STATE OF NEBRASKA
DEPARTMENT OF ROADS
ADDENDUM NO. 1
AND
ELECTRONIC BIDDING SYSTEM
AMENDMENT NO. 1
PROJECT NO. EACNH-2-3(116)
CONTROL NO. 60937
CALL ORDER F27
ON N-2 BETWEEN ANSELMO AND MERNA
LETTING DATE: FEBRUARY 7, 2002

CO:F27AD102

SURFACING UNDER CABLE GUARDRAIL

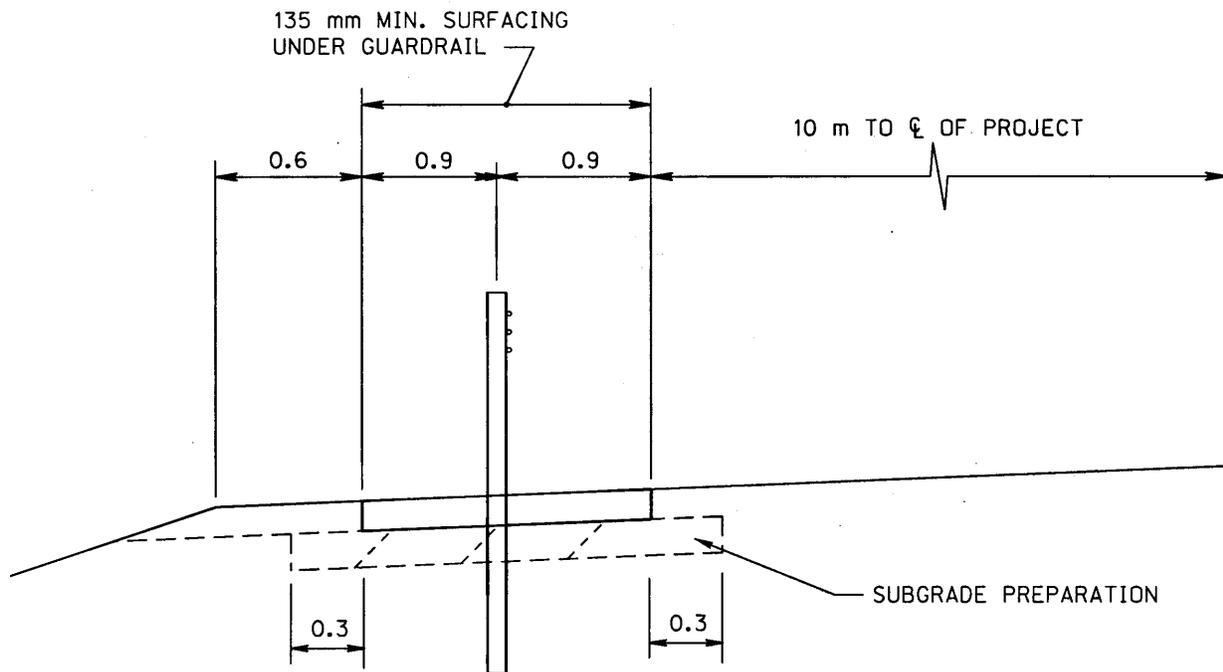
Plan sheet 2-T3 is amended to include the attached "Surfacing Under Cable Guardrail" detail.
